## FIREFOX

### Amplifone Raster Modification

#### 4. Deflection Board

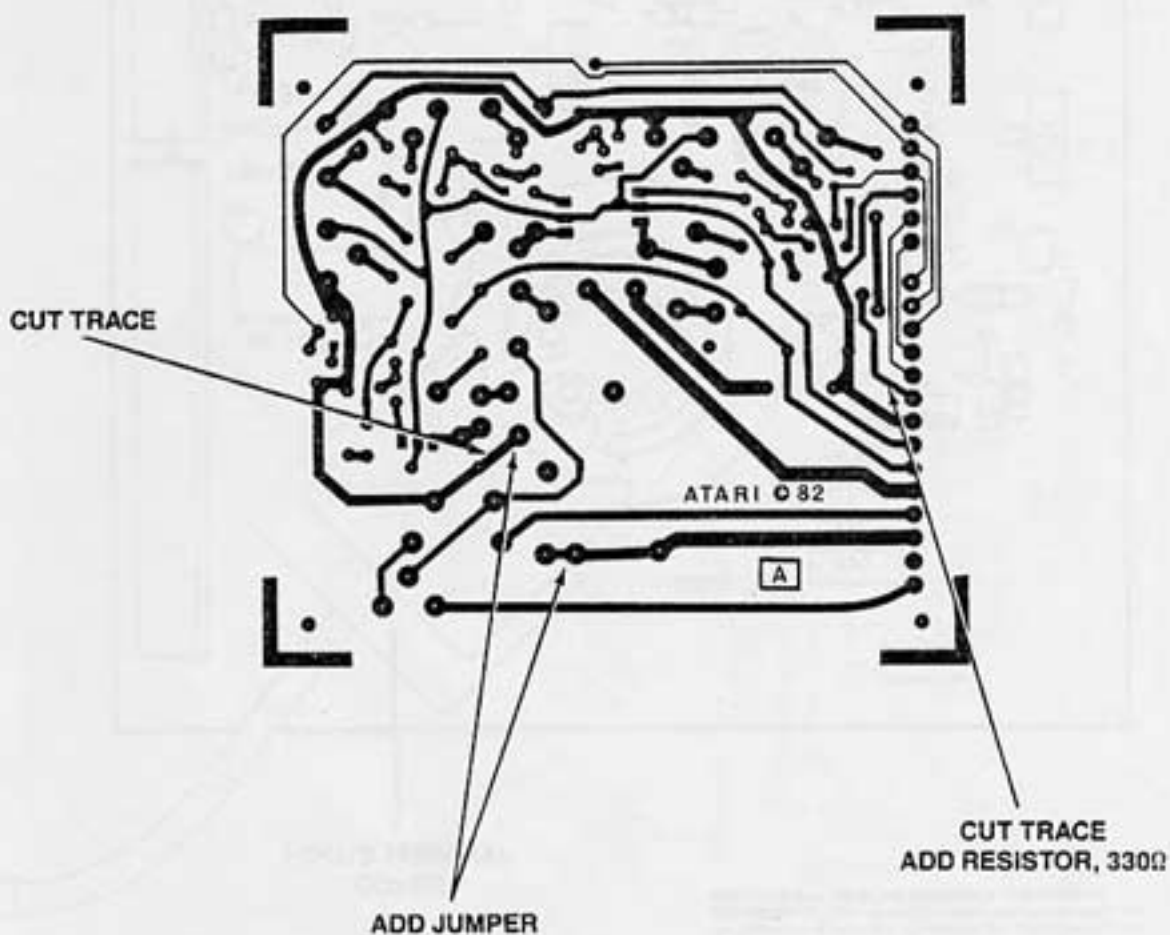
Install a 1N751A zener diode (5.1 V) to the vertical sync input, anode to ground, as follows:

- a. Locate the first pad connected to J1 pin 5 on the trace or circuit side of the board. Note: PLL board is installed in place of J1.
  - b. Locate the pad going to ground near J1 pin 6, between pin 6 and R10.
  - c. Install the zener diode (anode to ground) between these two pads on the circuit side of the PCB.
5. a. Remove C5 (0.1  $\mu$ F) axial cap.  
b. Install a 0.22  $\mu$ F (25 V) axial cap between the cathode and gate of Q4 (MCR101), soldering one lead of the cap to the cathode pad (square pad) of Q4 and the other lead to the pad of C5 connected to the gate of Q4. Install the cap on the circuit side of the PCB.
  6. Route the high-voltage anode lead away from the deflection board, and secure it with a wire tie wrap.

## Neck PCB Assembly

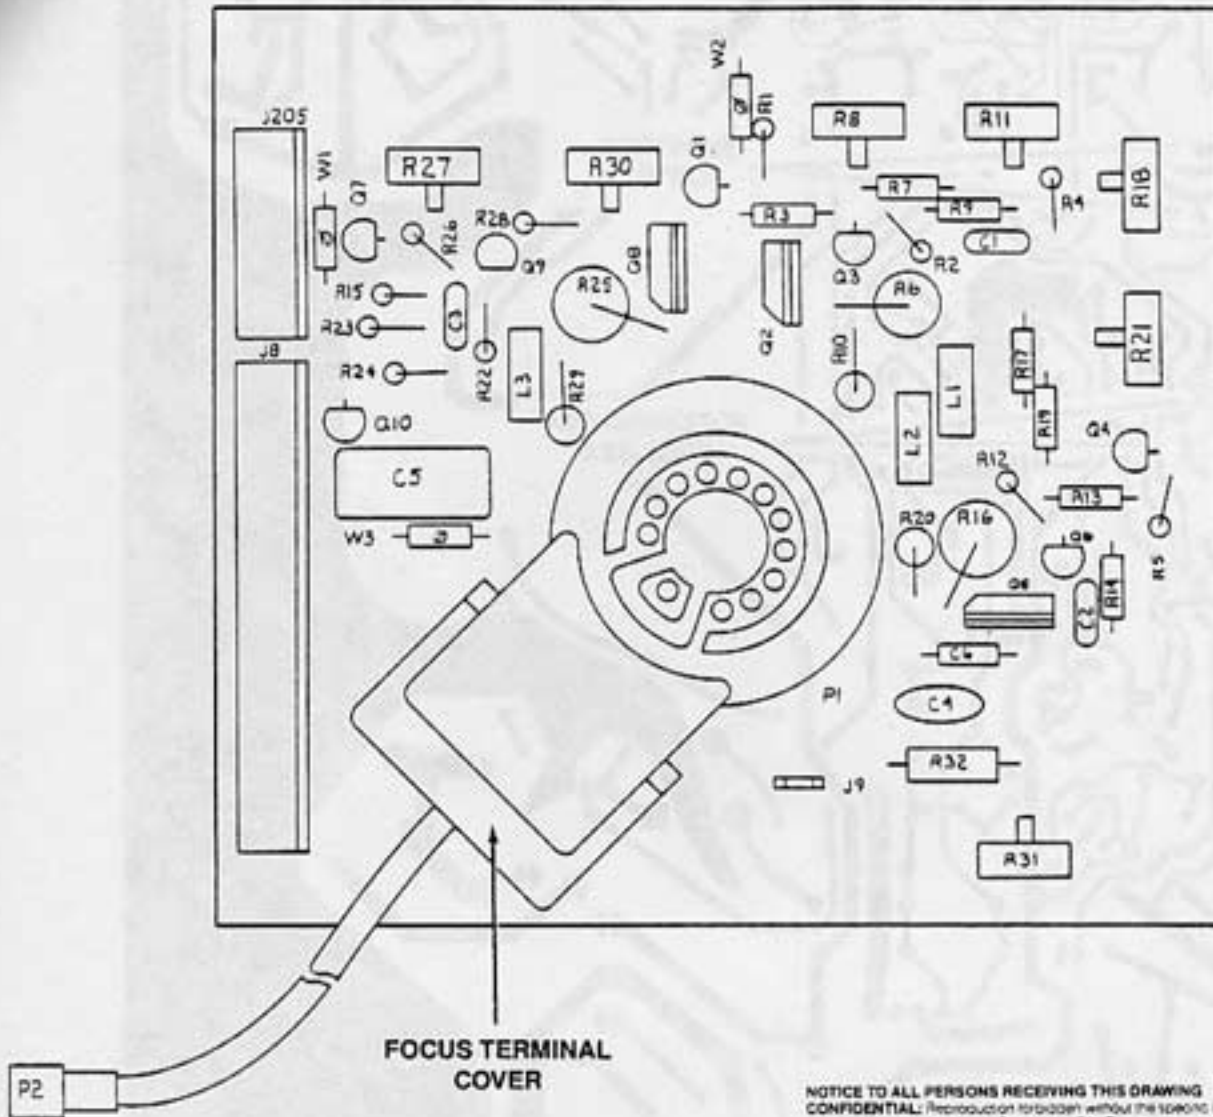
Cut the trace between the pad at CRT socket pin 5 and the nearest pad. Install an insulated jumper (1000 volts or better insulation) between pad at CRT socket pin 5 and either of the pads at spade lug J9. Use a number 20 wire.

2. Cut the trace between connector J8 pin 9 pad and the base pad of Q10. Install a 330 ohm,  $\pm 5\%$ ,  $\frac{1}{4}$  watt, resistor between the base of Q10 and the connector J8 pin 9 pad.

3. Remove the focus terminal cover from the CRT socket and unsolder the focus lead from the terminal. Solder a 22 meg-ohm,  $\pm 5\%$ ,  $\frac{1}{2}$  watt carbon-composition resistor to the terminal with the end flush with the terminal and resistor parallel to the board. Solder the focus lead flush with the other end of the resistor, and trim the resistor lead. Route the focus lead back to the exit groove, and replace the cover.
